Service Information

Category S	Repair Guidance	Ref. No. R054/18	Page 1 of 2
Coverage <input type="checkbox"/> Distributor only <input checked="" type="checkbox"/> Please inform your dealers		Date Issued September 12, 2018	
Please convey this information to your <input type="checkbox"/> Director <input checked="" type="checkbox"/> General Manager <input checked="" type="checkbox"/> Warranty Dept. <input checked="" type="checkbox"/> Parts Dept. <input checked="" type="checkbox"/> Training Dept. <input checked="" type="checkbox"/> Field Rep.		Date Revised	
Applicable Model CX-5 (KF) with Leather Seat		Applicable Countries and/or Vehicle Specifications Worldwide

Subject: Warping Surface of Driver's Seat

REPAIR PROCEDURE

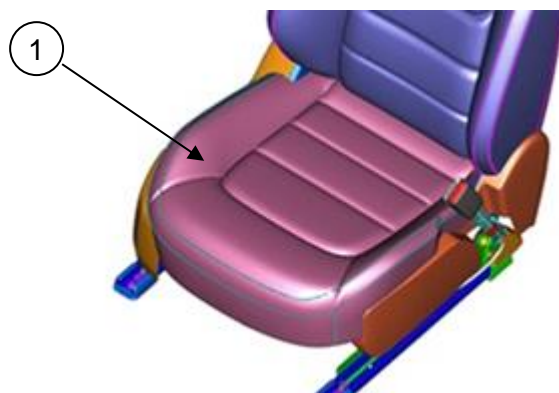
When you receive the customer complain on this concern, replace the front seat cushion trim(1) and the front seat cushion pad with a modified one according to the workshop manual "FRONT SEAT CUSHION TRIM REMOVAL/INSTALLATION".
